## ERCB Stakeholder Feedback—ERCBH2S, Version 1.20

### Stakeholder Feedback 1

Figure 1. Illustration of IIZ and PAZ (Transport Canada)

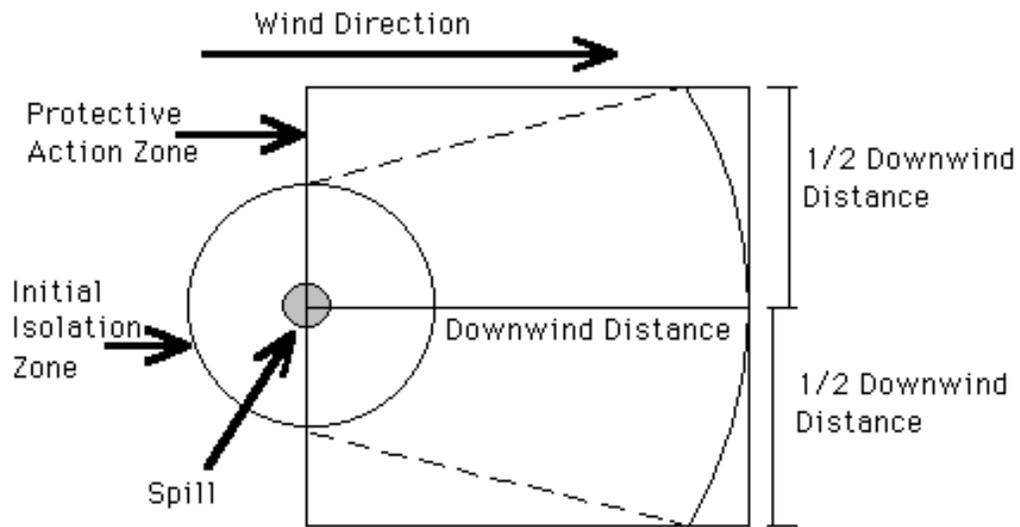
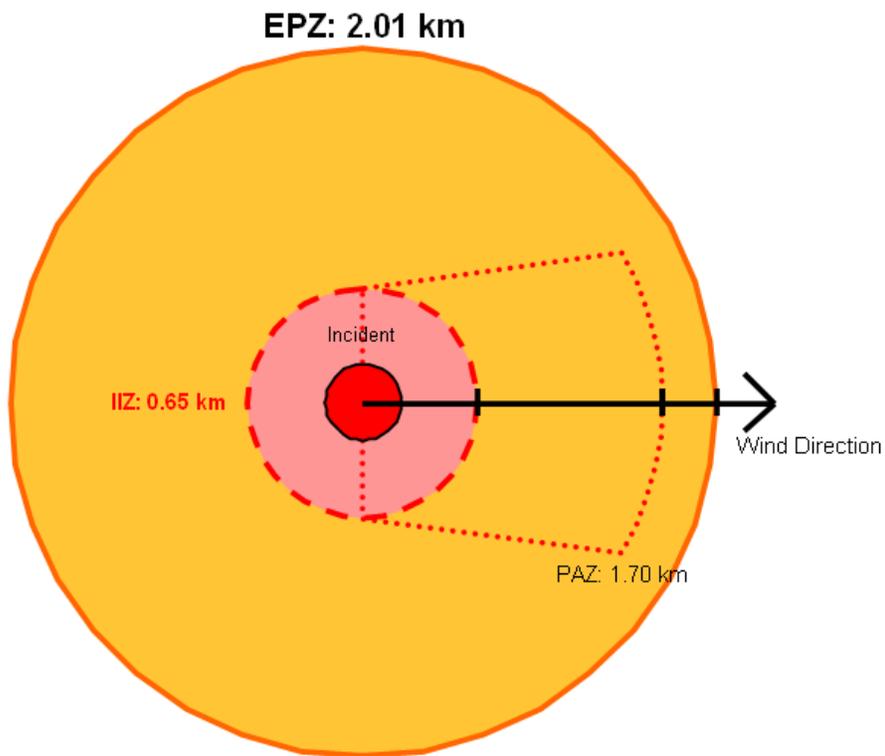
**Configuration of EPZ and PAZ:** Our assessment and comment on the apparent configuration of the EPZ and PAZ in the draft D071 is contingent upon on the ERCB response to the previous toxicology concerns. Therefore, the following may not apply. However, based on our current reading of draft D071, the PAZ zone is a subset of the EPZ, lying within the EPZ. In ERCB *Bulletin 2009-41*, the ERCB indicates that this configuration is aligned with that of other jurisdictions.

However, this configuration is in apparent contradiction to what is indicated by other jurisdictions. Using Transport Canada as a jurisdictional example, CANUTEC indicates the IIZ (the ERCB equivalent to this is the EPZ) is an area of downwind life threatening concentrations and the PAZ is a larger area of incapacitation and serious or irreversible health effects. That is, the CANUTEC zone of serious or irreversible health effects is larger (not smaller) than the zone of lethality.

Although the ERCB uses some of the same nomenclature as CANUTEC, the definitions are different. The ERCB IIZ is an indoor concentration whereas for CANUTEC it is outdoor. Thus, the Transport Canada/CANUTEC definition of IIZ as an outdoor zone of life threatening health effects is equivalent to the ERCB EPZ. The ERCB definition of IIZ is that it is the indoor zone of life threatening health effects. Transport Canada/CANUTEC has no equivalent to the ERCB definition of IIZ. Most significantly, the CANUTEC zone of serious and irreversible health effects is outside the lethality zone, which is opposite to the ERCB. We support the ERCB inclusion of an indoor zone.

Comment	ERCB Response
We recommend review and comparison of jurisdictional emergency planning areas and definitions to those used by the ERCB to ensure functional alignment and clarity.	<p>The ERCB configuration of PAZ (unconsciousness—which is more serious) and EPZ (unconsciousness by ~2.5 times toxic load—which is less serious) is aligned with that of other jurisdictions, such as the Transport Canada IIZ (life threatening—which is more serious) and the Transport Canada PAZ (incur serious or irreversible health effect—which is less serious).</p> <p>When the ERCB revised ERCBH2S as detailed in <i>Bulletin 2009-041</i>, the technical reference documents (Volume 1-3) were not updated, and past definitions/information was available on outdated model versions.</p> <p>With the release of the finalized ERCBH2S Version 1.20, these reference documents will be undated and revised to reflect the models.</p>
